Florida Greenbook

Sub-committee Meeting

Chapter 8 – Pedestrian Facilities

February 3, 2026
4:00 PM – 5:00 PM

Figure 8-2 Shoulder Point with Sidewalk

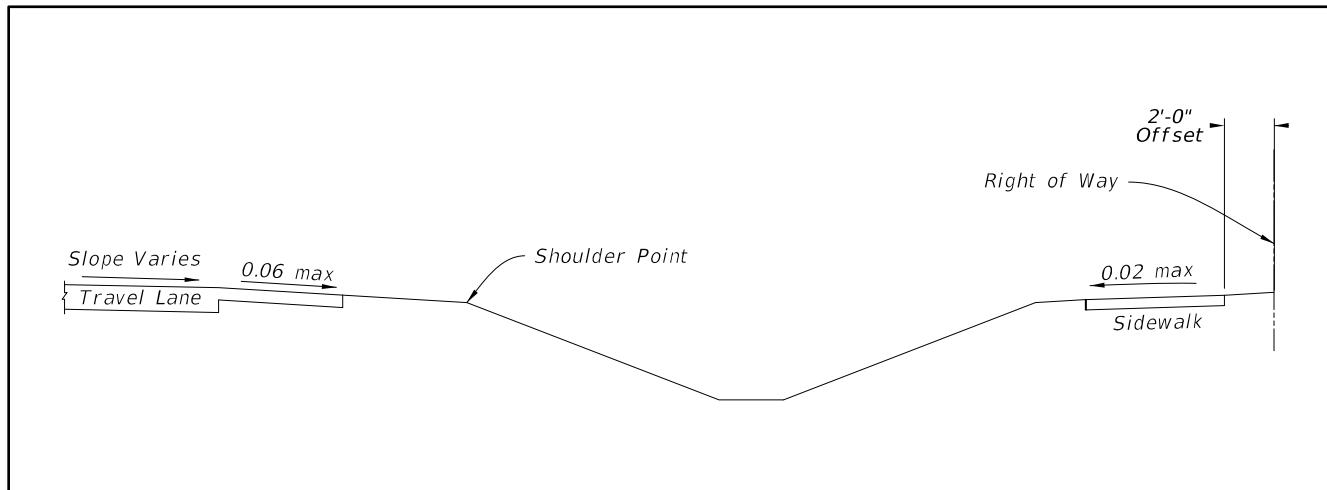
[Update the graphic to show 3' behind the sidewalk for above utilities, not 2'. As indicated in 8.3.2.1.1.]

Figure 8-3 Pedestrian Bridge Typical Section

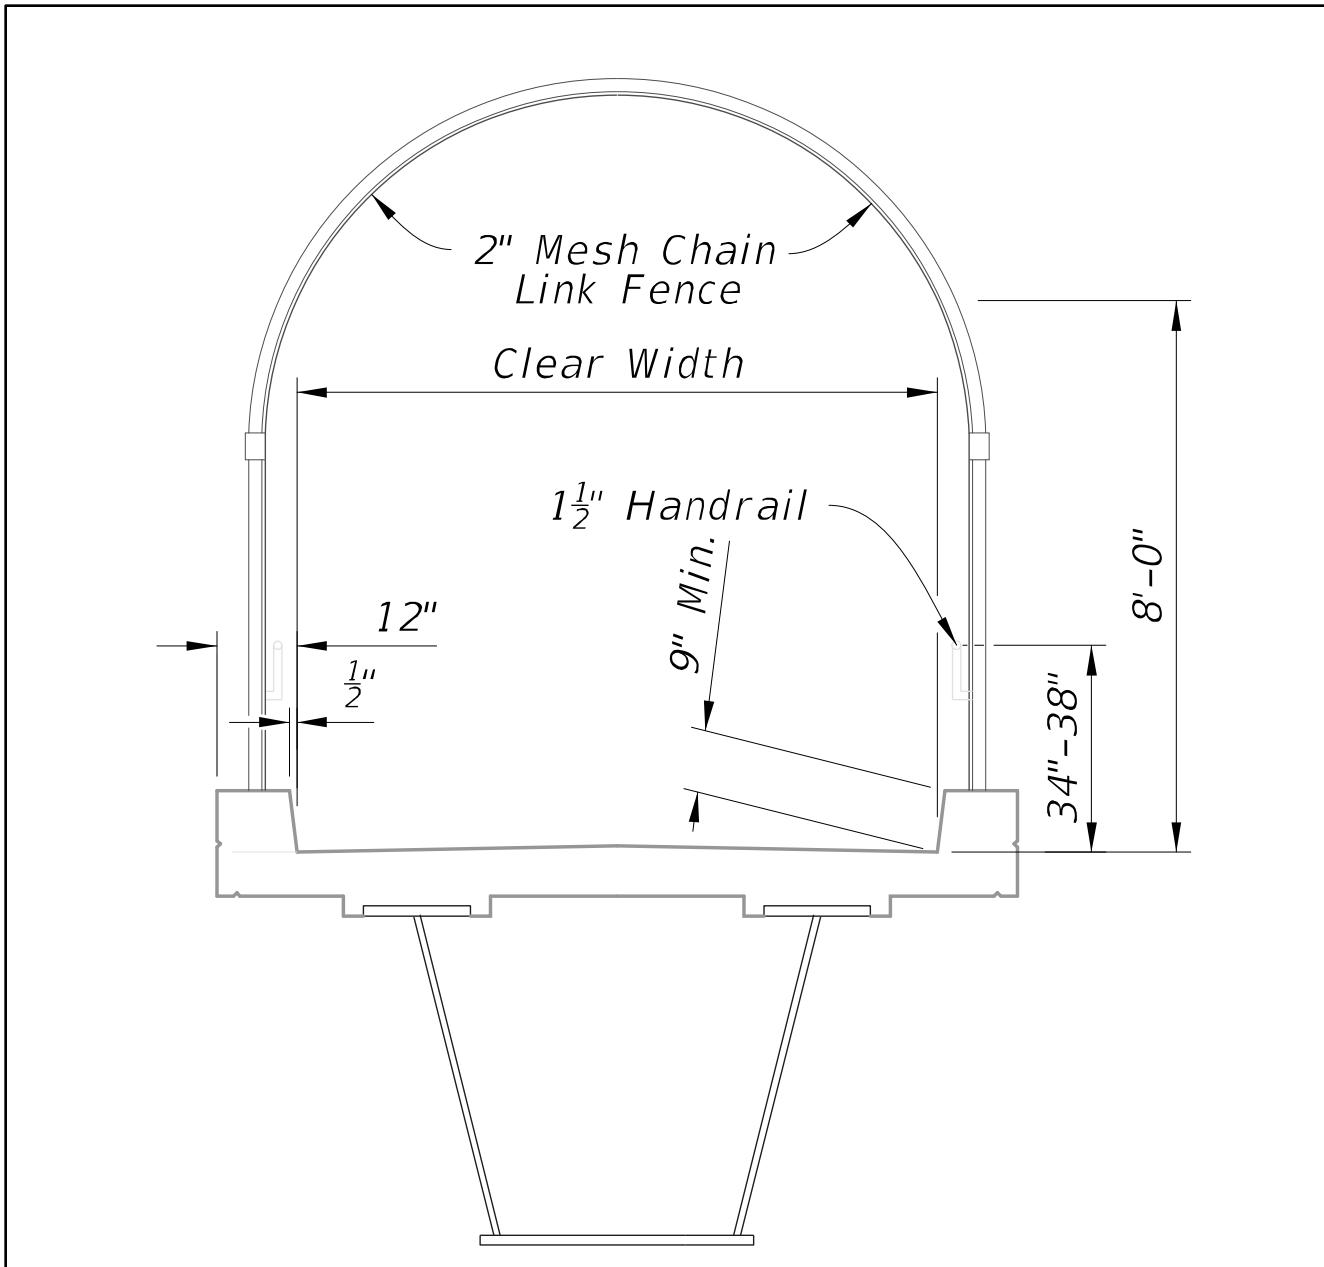
[Redraw dimensions to show where the 8' is capped]

Figure 8-9 Example Curb Ramps

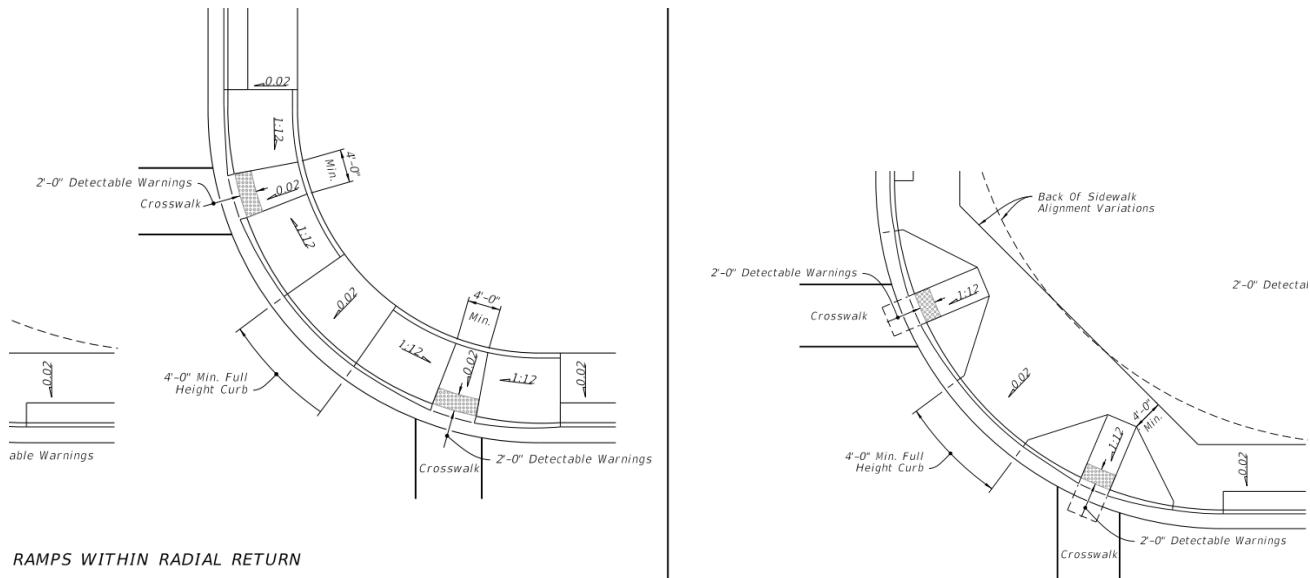
[Currently FDOT drawings. Option to redraw in FGB style.]

Figure 8-10 Example Detectable Warnings

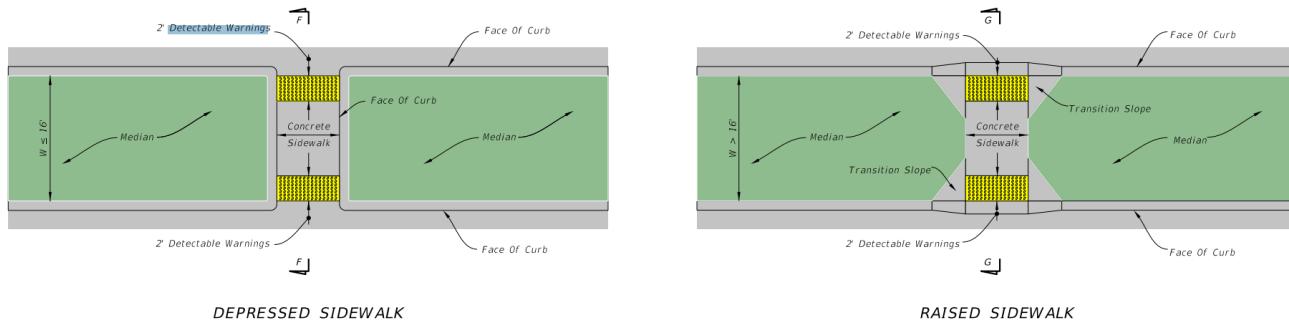
[Option to redraw in FGB style]
